ADDENDUM NO. 1 TO
CONTRACT DOCUMENTS, SPECIFICATIONS AND PLANS
FOR LOCKHART MUNICIPAL AIRPORT
TXDOT CSJ # 2614LHART

Airfield Fencing

REVISED PLAN SHEETS C951, C952, AND E250 (following)

C951

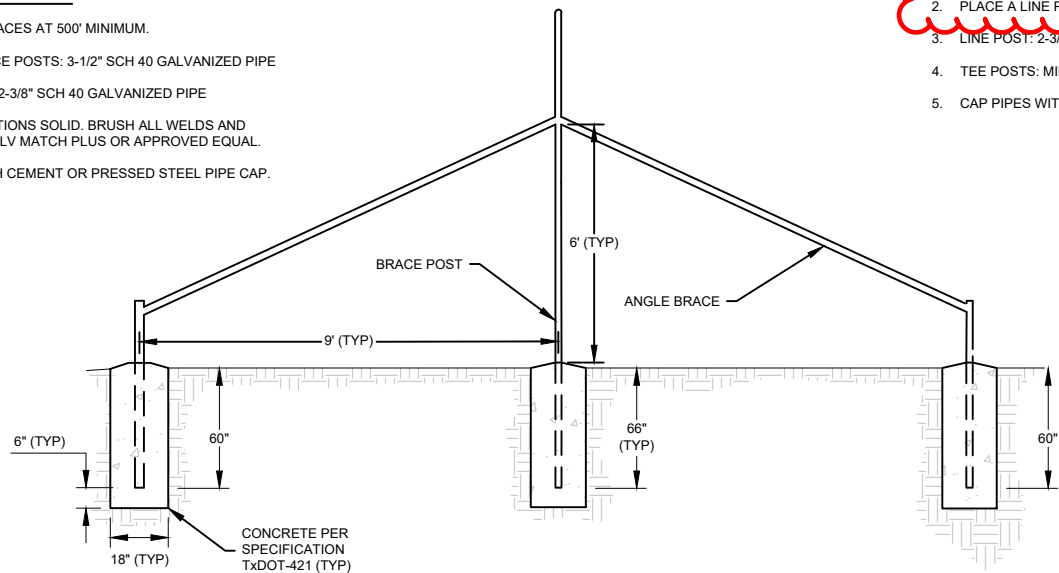
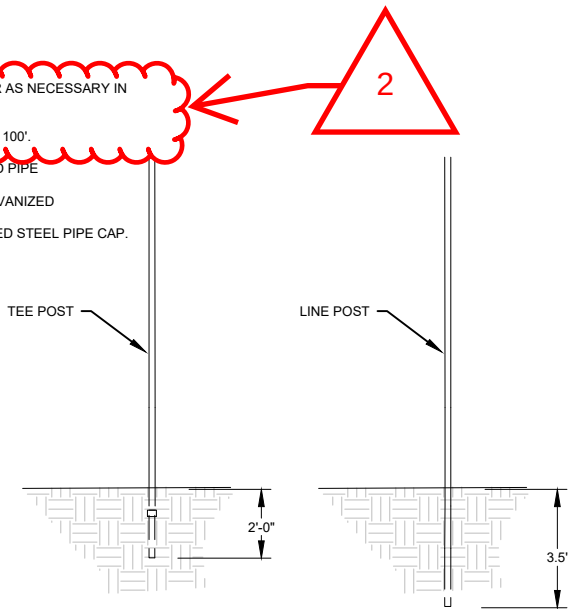
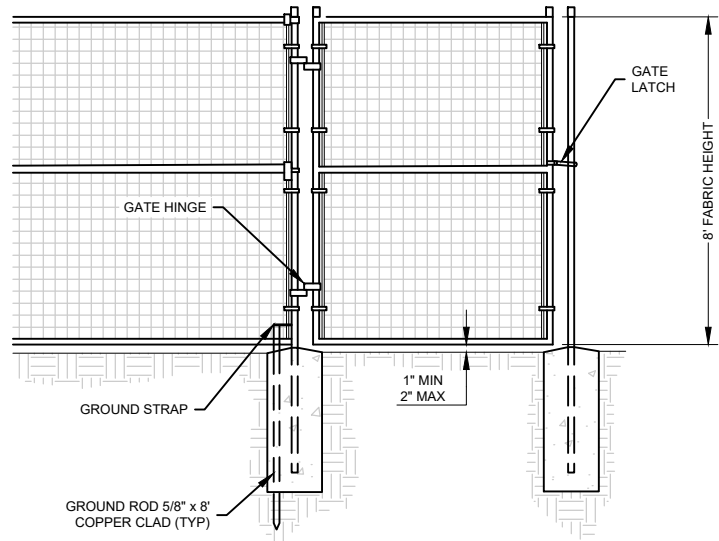
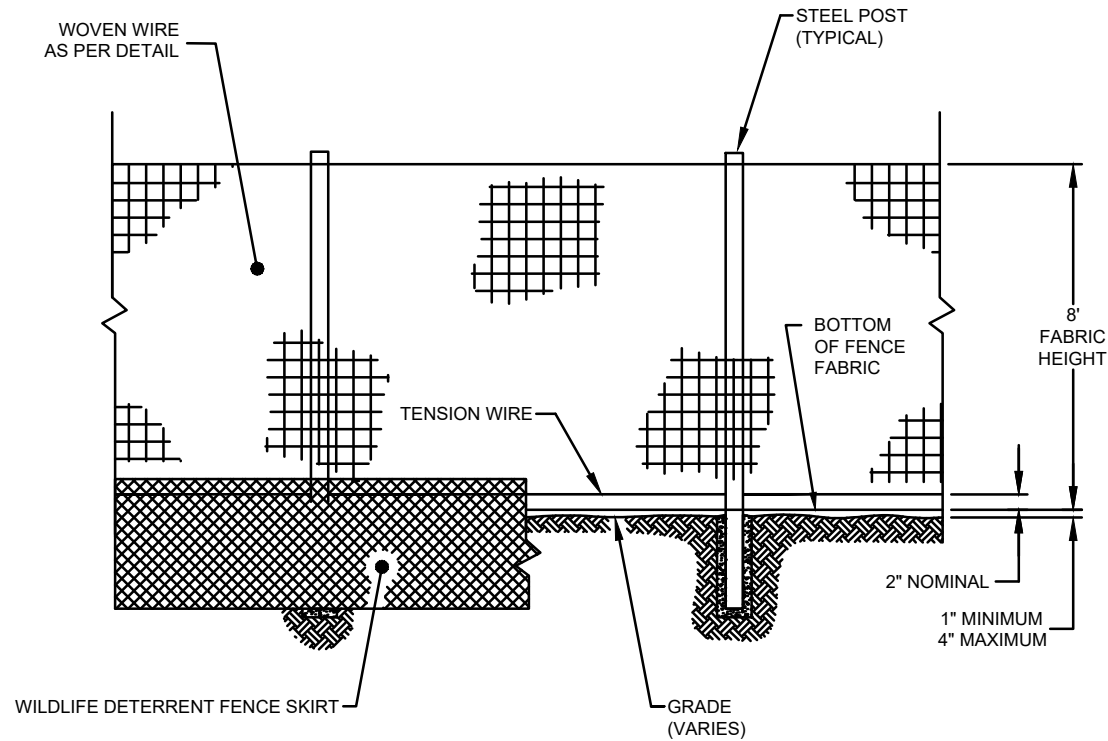
Modified Sheet C951 as follows:

- Modified T post spacing to 12' minimum
- Simplified Line Post spacing language

1. SPACE TEE POSTS AT 12' OR CLOSER AS NECESSARY IN ROUGH TERRAIN.
2. PLACE A LINE POST AT LEAST EVERY 100'.
3. LINE POST: 2-3/8" SCH 40 GALVANIZED PIPE
4. TEE POSTS: MINIMUM 1.33 LB/FT GALVANIZED
5. CAP PIPES WITH CEMENT OR PRESSED STEEL PIPE CAP.

C952

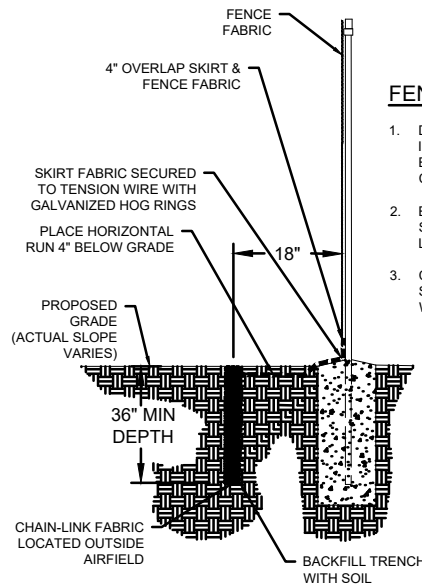
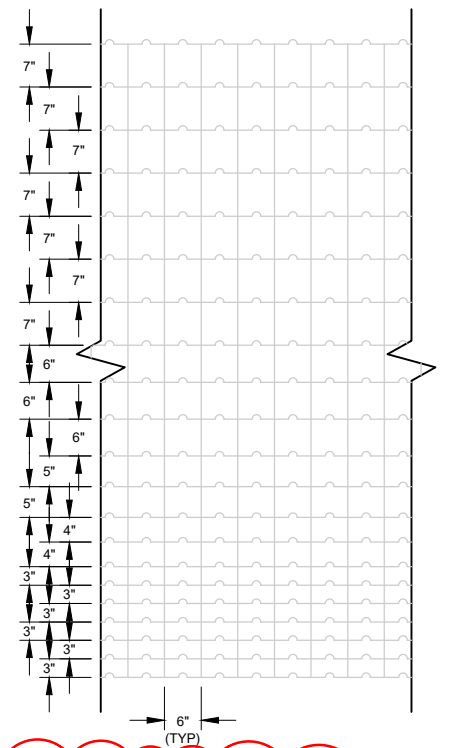
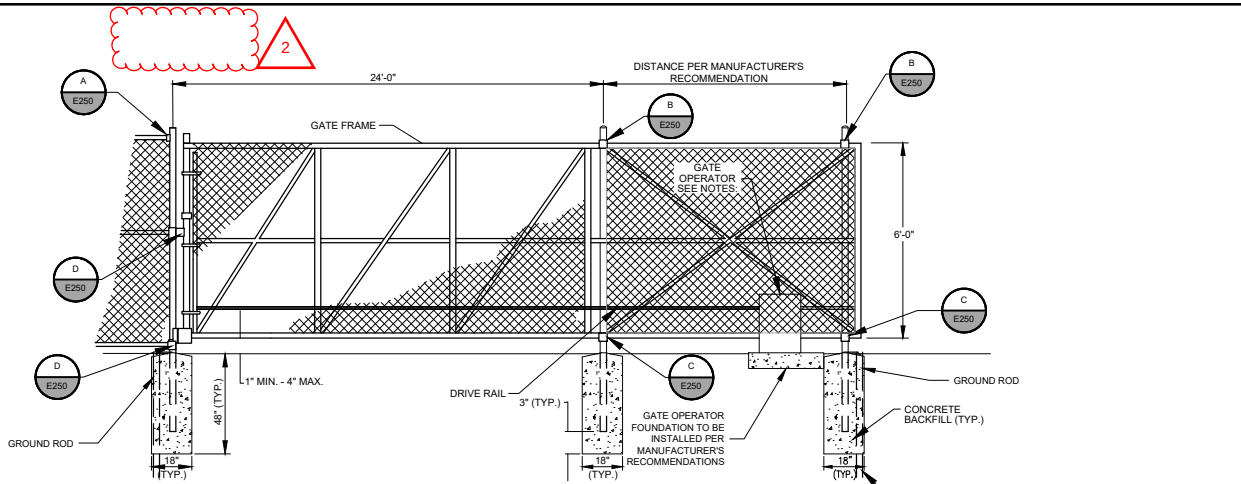
Question: Are staples required to secure the apron to the ground?

Modified Sheet C952 as follows:

- Replaced Details for Fence and Predator Apron. **NOTE THAT THE APRON IS REQUIRED TO BE PLACED VERTICALLY BELOW GROUND** as per the detail. The apron is not to lay flat.
- Added language to Game Proof Fence General Notes #4 that ground rods shall be placed at fence crossings in addition to every 500' of fence.
- Removed Predator Apron mesh detail. This is to be constructed of chain link material.
- Added the title "Game Proof Fence Mesh Detail" to existing detail.

Response: The apron requirement is hereby modified so that the apron will be buried below ground. As such, no staples will be needed. Please see replacement plan sheet C952 and specification F-164.

E250

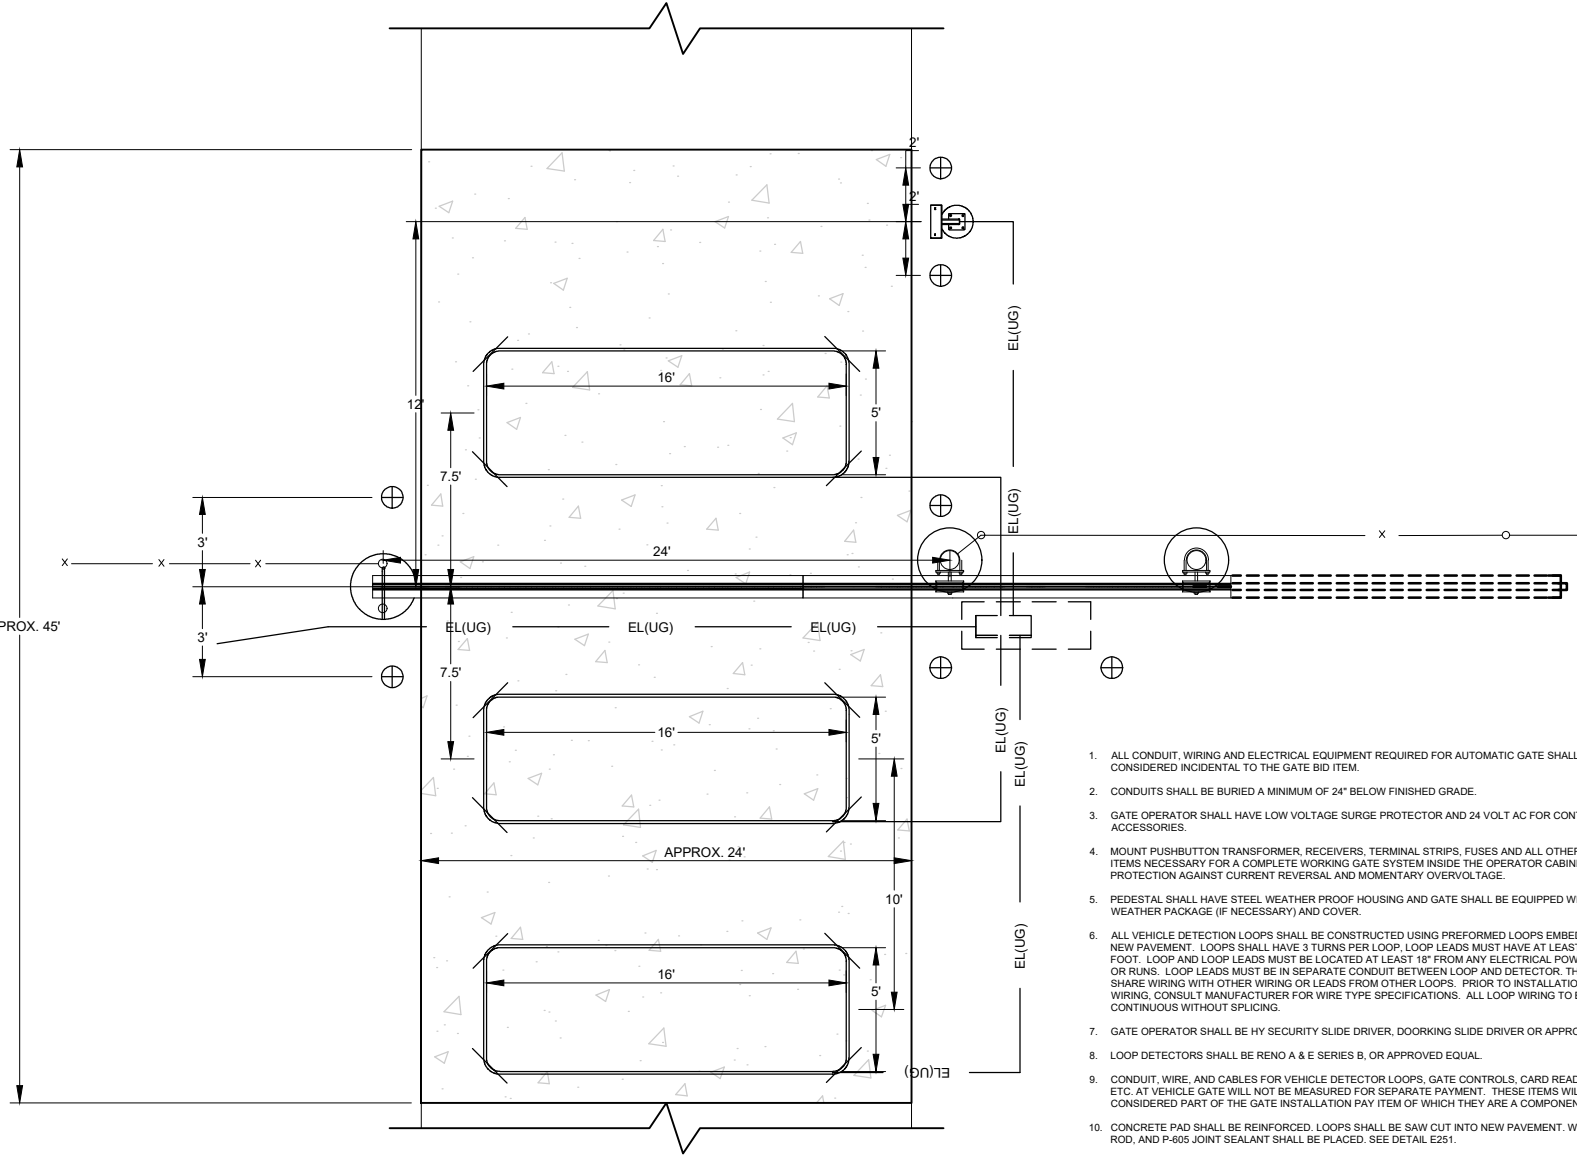
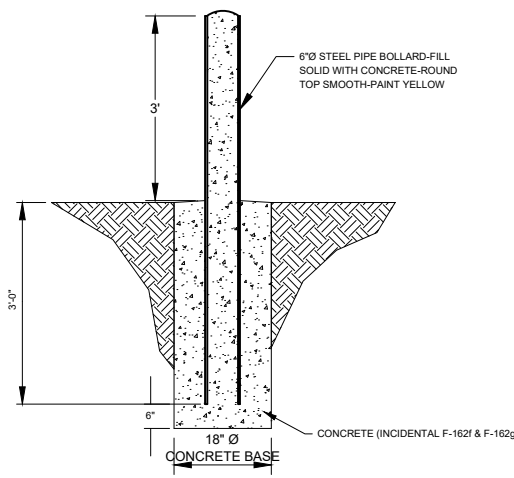
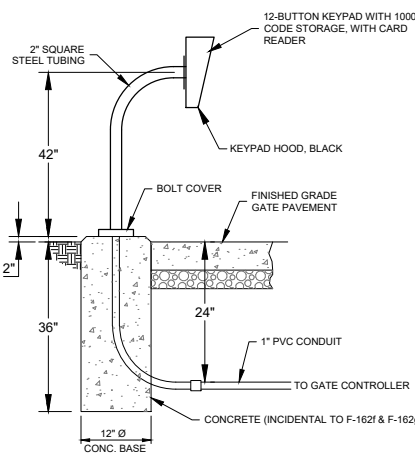
1. UL 325 Gate Operator Classification

Sheet E250, General Note 7 requires the automatic gate and components to be designed, constructed, and installed in accordance with UL 325 and ASTM F2200, but does not specify a gate operator class (I, II, III, or IV). Given the airfield perimeter application, we anticipate a Class III or Class IV operator will be required. Please confirm the required UL 325 classification so our gate subcontractor can price the correct operator and associated safety devices (entrapment protection, photo eyes, safety edges, etc.).

2. Access Control System Scope

The plans call for a 12-button keypad with 1,000-code storage and a card reader (Sheet E250). No access control software platform, offsite/remote programming capability, personnel or vendor management functionality, or time-based access scheduling is specified. Please confirm whether this basic local keypad/card reader system is the full intended scope, or whether a more sophisticated integrated access control system is expected for this facility. If the latter, please provide the detailed specification for the controller/software platform so it can be properly priced.

3. Gate Frame Structural Detail

Sheet E250, General Note 8 specifies the gate frame as 2"x4" rectangular aluminum tubing with welded connections, but does not provide wall thickness/gauge, wind load design criteria, or other structural detail for the ~24' opening / ~45' cantilever track. Please advise whether additional structural details or an engineered design for the gate frame will be issued, or whether the contractor/gate manufacturer is expected to engineer this component to meet a specified wind load.

Modified Sheet E250 as follows:

- Removed extraneous reference to Additive Alternate. There is not additive alternate.
- Changed Note 10 to refer to Specification F-164
- Added language to Note 7 to specify UL 325 Class III Operator
- Added language to Note 8 to specify ASTM F114 Type 2 Class II Gate Frame.

The gate operator shall be Class III and meet the requirements of UL 325.

The gate controls key pad/card reader shall be standalone to this specific gate and does not require an access control system. There should be simple local programming to add or delete users, and event log.

The gate frame shall be meet ASTM F1184 Type II, Class 2 and ASTM 2200 for this application.

- THE AUTOMATIC GATE SHALL BE EQUIPPED WITH A PHOTO BEAM EYE AND INSTALLED PER INDUSTRY STANDARD IN REGIONS WITH SNOW ACCUMULATION.
- THE AUTOMATIC GATE AND COMPONENTS SHALL BE DESIGNED, CONSTRUCTED AND INSTALLED IN ACCORDANCE WITH UL 325 CLASS III AND ASTM F2200.

- GATE FRAME SHALL CONSIST OF 2"x4" RECTANGULAR TUBING (ALUMINUM) FOR THE AUTOMATIC AND MANUAL CANTILEVER GATES. ALL CONNECTIONS SHALL BE WELDED WITH NO MECHANICAL CONNECTORS. GATE FRAME SHALL MEET THE REQUIREMENTS OF ASTM F114 TYPE II CLASS 2.
